Air Pollution Control District San Luis Obispo County

## APCD Review of "Scripps/UCSD Interim Report 2021"

#### November 2, 2021

The San Luis Obispo County Air Pollution Control District ("APCD" or "District") offers this review of "Scripps/UCSD Interim Report 2021: Preliminary Results from the May 2021 Aerosol Measurements," by Scripps/UCSD Professor Lynn Russell. These comments are specifically on the version dated September 30, 2021, provided to the District on about October 1, 2021. The District appreciates the opportunity to provide these comments.

Figure 4: Correlation between Humidity and PM<sub>10</sub> BAM concentrations. For consistency with the Scripps report, only data from the period of Scripps's 2021 sampling is shown.

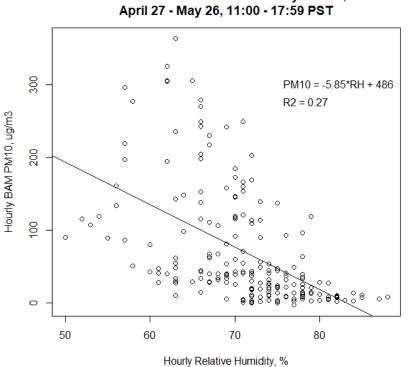
With regard specifically to water, the District notes that at CDF humidity and BAM  $PM_{10}$  are negatively correlated (r = -0.52), as shown in Figure 4, below.
